ROBERTS ROAD DATA CENTRE (SSD-10330) - RESPONSE TO SUBMISSIONS

Prepared for
CANBERRA DATA CENTRES PTY LTD
28 May 2020

Figure 1 Updated Site Plan

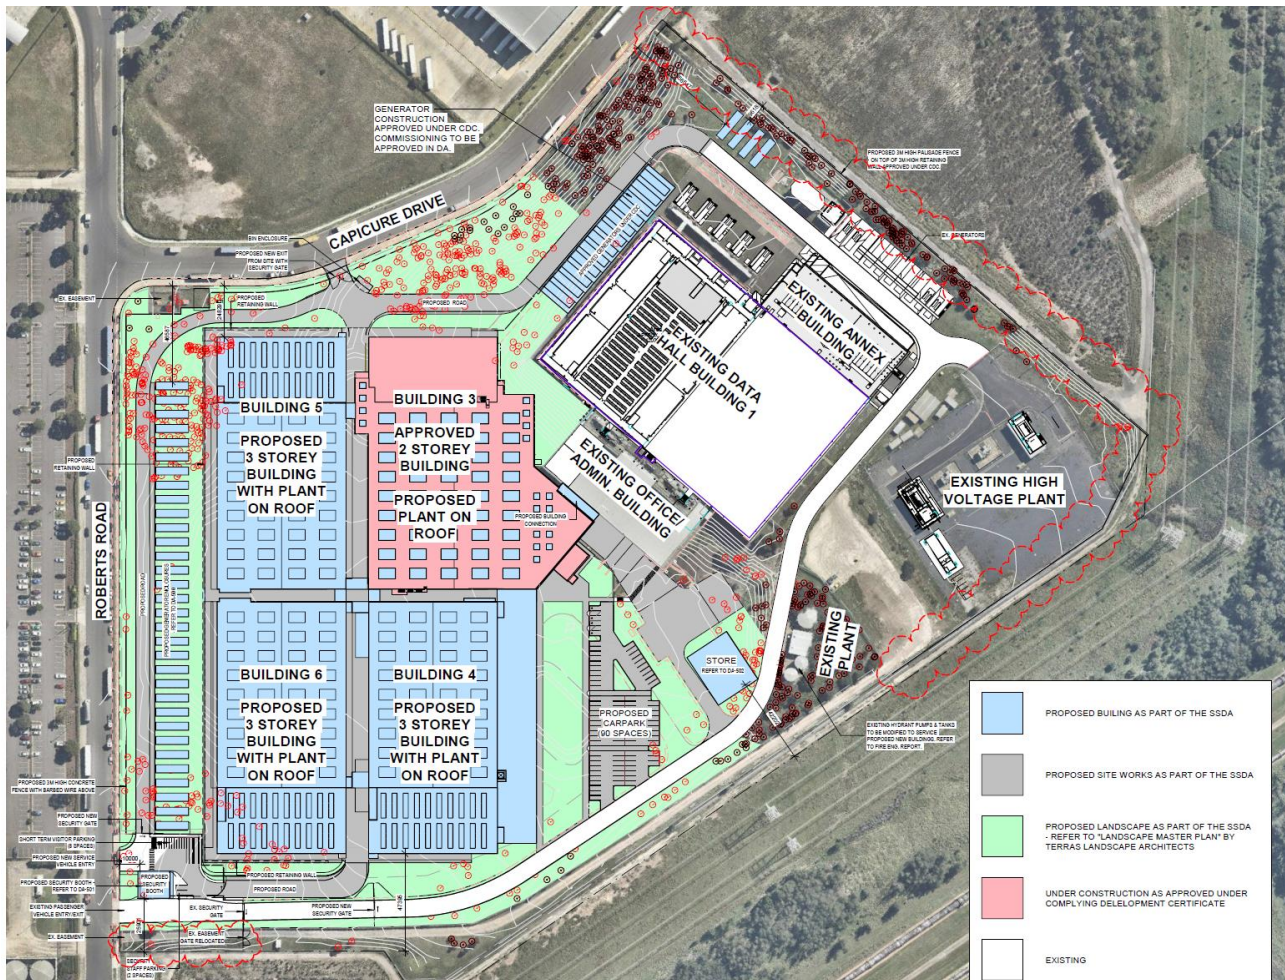
The changes are summarised below (refer to Figure 1 for updated site plan):

- Housing the 36 generators in individual enclosures and relocate 4 generators to the northeast of the site.
- The 12 generators located to the north of the site were approved under Complying Development Certificate for installation only (ref. no. 5809/3). These generators have now been included in the SSDA scope to seek consent for the commissioning and operation of these generators. The total number of backup generators servicing the proposed Data Centre is retained - 48 in total.
- Amend internal warehouse layout to accommodate additional storerooms and switch rooms to satisfy data centre servicing requirements.
- Raise the chiller deck to level 2 to create additional roof space below for the storeroom and switch rooms (refer to Figure 2). The maximum height of the building is retained.
- Extending the palisade fence along the north-eastern boundary of the site.

Figure 3 Updated Landscape Masterplan

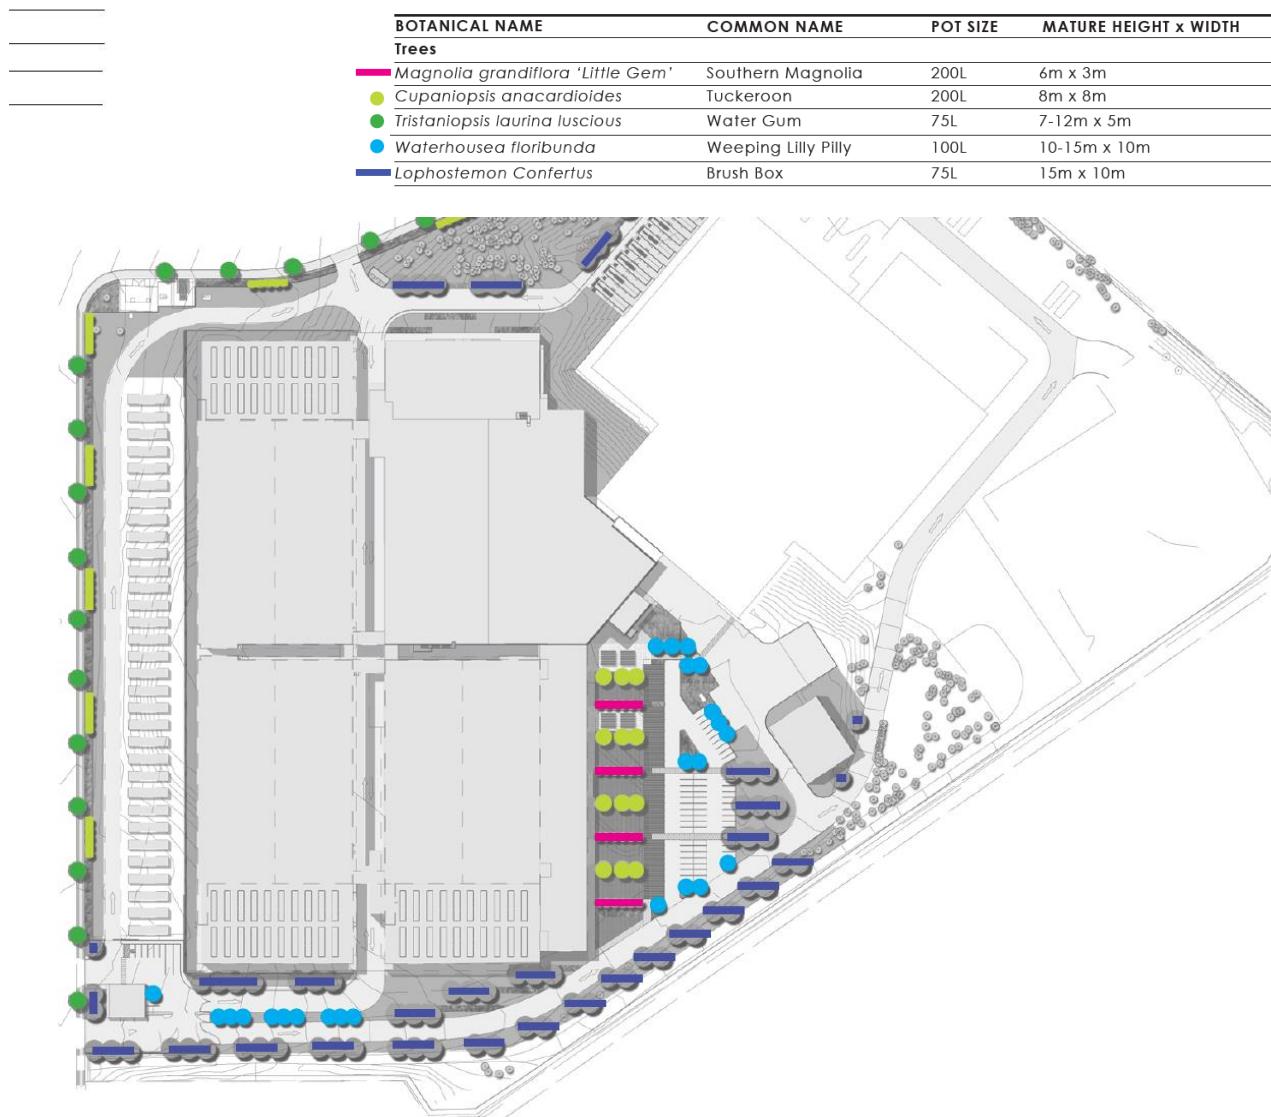
In accordance with Blacktown City Council's comments, landscape masterplan has been updated to replace the following species (refer to Figure 3):

- *Pyrus calleryana* 'Capital' trees have been replaced with *Lophostemon confertus* 'Brush Box', which will provide a larger tree canopy (mature height of 15m x 10m wide) along internal roadways to the north and south of the data centre building.
- *Elaeocarpus grandis* trees have been replaced with *Cupaniopsis anacardioides* 'Tuckeroo', which will provide shade and is better suited to the local climate.

Figure 4 Site Plan showing generators onsite

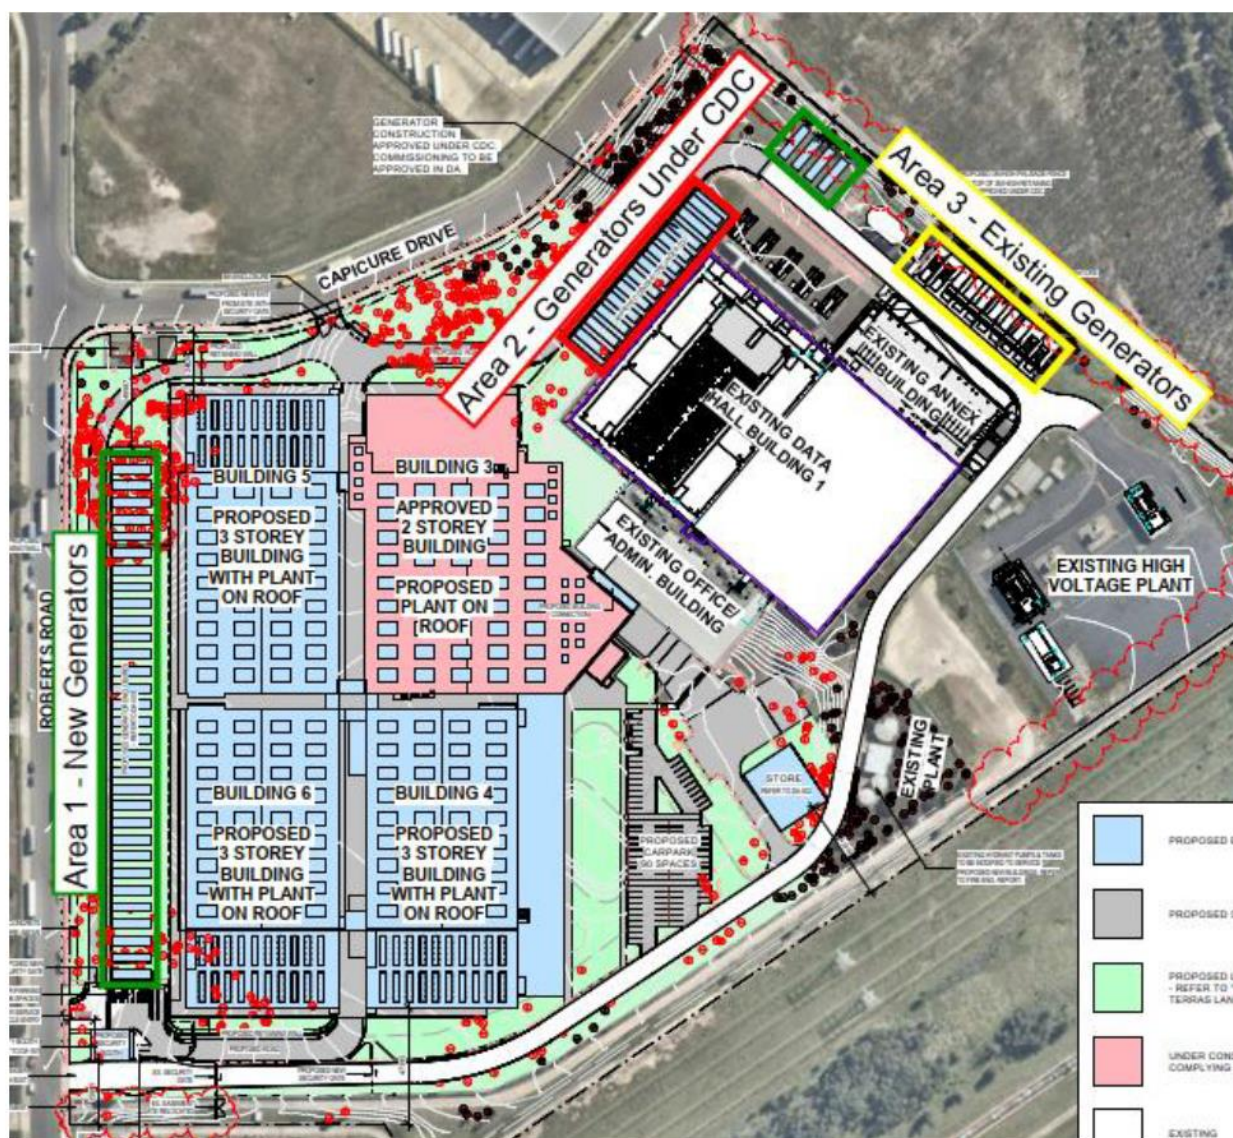
A statement prepared by Lote Consulting (attached at Appendix E) confirmed that the overall site accommodates a total of 58 diesel generators (refer to Figure 4):

- Area 1: As part of the SSDA, a total of 36 new generators are proposed to be installed in individual closures.
- Area 2: A total of 12 generators were approved for installation under a Complying Development Certificate (CDC). The CDC however did not approve for the commissioning of these generators; therefore these 12 generators have been included in the scope of the SSDA.
- Area 3: The existing data centre comprises of a total of 10 generators. Area 3 is excluded from the Dangerous Goods Assessment and the SEPP 33 Review, as they are existing generators and not part of the SSDA scope,

The proposed and existing generators all have a 33,000L day tank for the storage of diesel.

The total quantity of 1,914,000kg of diesel equates to 1,883 tonnes. The total combined diesel storage from the proposed and existing data centre does not exceed 2,000 tonnes, and the proposal does not trigger

clause 9, Schedule 1 of the *Protection of the Environment Operations Act 1997 (POEO) Act*. Accordingly, the proposal is not required to obtain a scheduled activities license for diesel storage.

Figure 5 Sensitive Receptors location

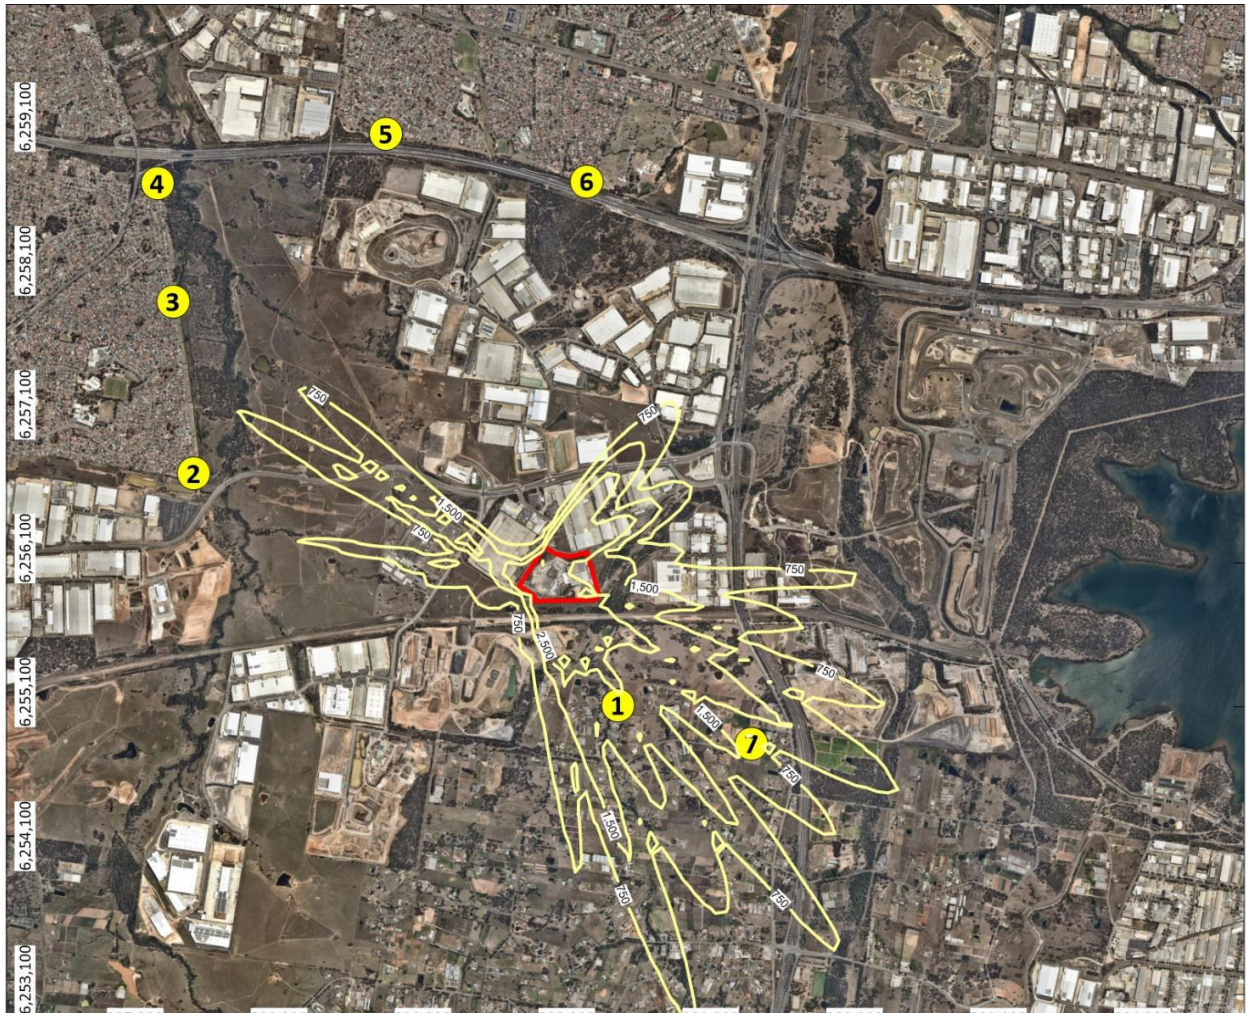
Six sensitive receptors have been identified and considered in the assessment (refer to Figure 5).

Figure 6 Acoustic Barrier location

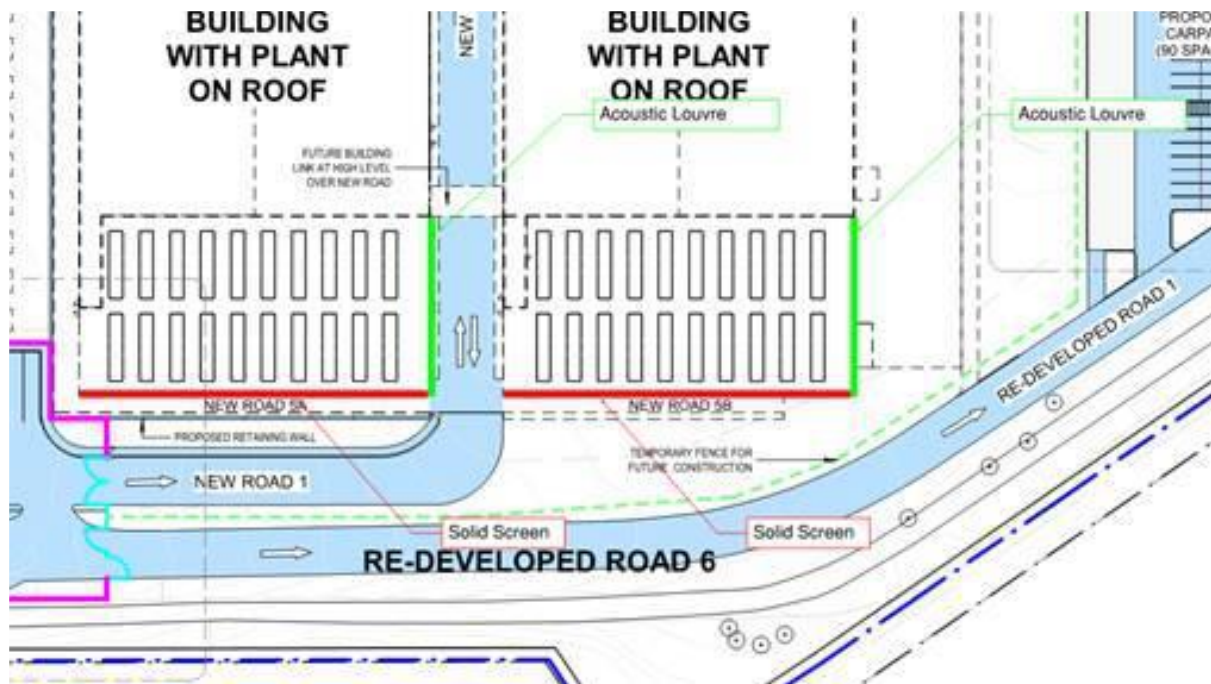
To meet the PNTLs during the testing and maintenance of the generators, the following noise mitigation measures have been recommended:

- A solid acoustic barrier should be implemented in the design in the location shown in Figure 6, with height 3300mm above the FFL of the plant deck. The performance of the solid acoustic barrier shall meet the minimum transmission loss values for each octave band centre frequency shown below.
- An acoustic louvre should be implemented in the design in the location shown in Figure 6, with height 3300mm above the FFL of the plant deck. The performance of the acoustic louvre shall meet the minimum transmission loss values for each octave band centre frequency shown below.

The acoustic barrier and louvre have been incorporated in the updated Architectural Plan as shown on Roof Plan - DA-103 Rev. F and Elevation Plan - DA-200 ver. E.

Item	Transmission Loss dB					
	125 Hz	250 Hz	500 Hz	1 kHz	2 kHz	4 kHz
Solid Acoustic Barrier	19	24	28	33	31	34
Acoustic Louvre	9	14	19	21	24	24
